UNITED STATES PATENT AND TRADEMARK OFFICE

APPLICATION NO.	FILING DATE	FIRST NAMED INVENTOR	ATTORNEY DOCKET NO.	CONFIRMATION NO.
10/826,003	04/16/2004	Shih-Chang Shei	JCLA12118	9227
23900	7590	09/21/2007		
J C PATENTS, INC. 4 VENTURE, SUITE 250 IRVINE, CA 92618			EXAMINER ANDUJAR, LEONARDO	
			ART UNIT 2826	PAPER NUMBER
			MAIL DATE 09/21/2007	DELIVERY MODE PAPER

Office Action Summary	Application No. 10/826,003	Applicant(s) SHEI ET AL.	
	Examiner Leonardo Andújar	Art Unit 2826

DETAILED ACTION

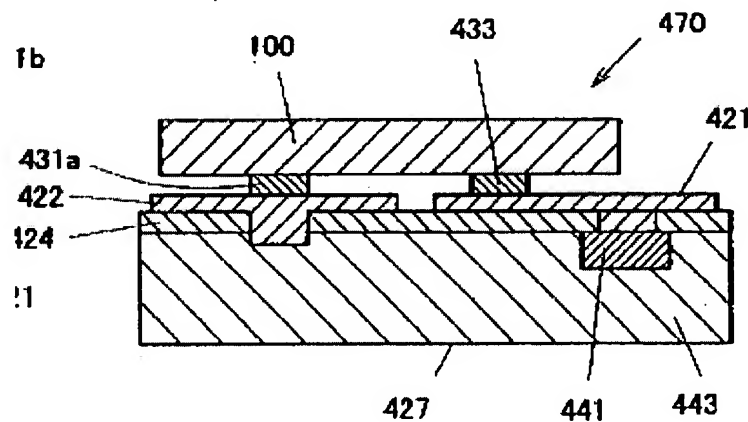
4. Regarding claim 7, Hirano (e.g. 11A & 11B, col. 3/figs. 58-61) teaches most aspects of the instant invention including a light-emitting diode package structure, comprising: a semiconductor sub-mount 443 having a first surface; a first patterned conductive-reflective film 421 set up on a portion of the first surface; a second patterned conductive-reflective film 422 set up on a portion of the first surface, and a light-emitting diode chip 100 set up on the semiconductor sub-mount, wherein the light-emitting diode has a first electrode (e.g. electrode connected to 431a) and a second electrode (e.g. electrode connected to 433) electrically connected to the first patterned conductive-reflective film and the second patterned conductive-reflective film but does not disclose that the first surface has a cavity having a first sidewall, a bottom surface, and a second

sidewall. Therefore, Hirano does not teach that the first pattern is set up on a portion of the first sidewall, bottom surface, that the second portion is set up on a portion of the second sidewall bottom surface and the diode set up inside the cavity. Also, Hirano does not show that the first and second patterned conductive reflective films substantially and respectively cover the first and second sidewall of the cavity (.

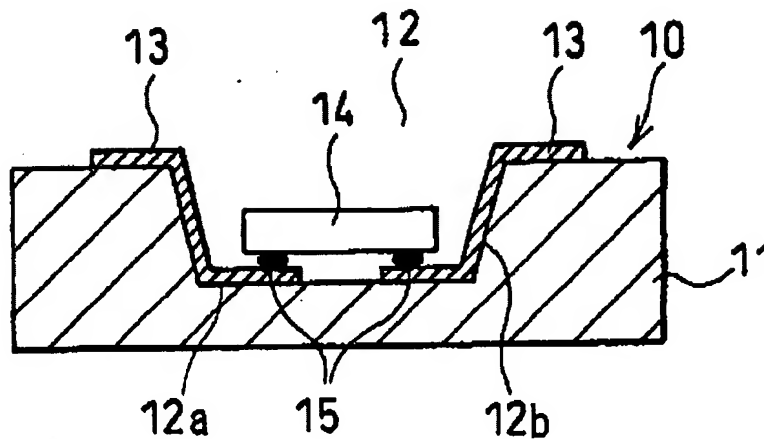
Nevertheless, Tominaga (e.g. fig. 2) shows a light emitting diode package structure having silicon sub mount 11 having a first surface including a cavity 12 including a bottom surface, a first sidewall and a second sidewall wherein a first conductor 13 is set up on a portion of the first surface, bottom surface and first sidewall, a second conductor 13 set up on a portion of the first surface and a second sidewall and a light emitting diode 14 set up in the cavity (pp 0005).

Okazaki teaches that the emission efficiency can be improved by substantially covering the first and second sidewall of the cavity using a first and second metal reflective materials 18/19 (e.g. fig. 6; col. 2/lis. 56-60; col. 4/lis. 60-64).

It would have been obvious to one of ordinary skill in the art at the time the invention was made to include a cavity having a bottom surface, a first and a second sidewalls in the first surface of the sub mount disclosed by Hirano wherein a first conductor is set up on a portion of the first surface, bottom surface and first sidewall, a second conductor set up on a portion of the first surface and a second sidewall, and a light emitting diode set up in the cavity as suggested by Tominaga to provide a more compact package since the overall thickness is reduced and to make the first and to make the first and second patterned conductive reflective films substantially covering the first and second sidewalls of the cavity as suggested by Okazaki to improve the emission efficiency of the device.
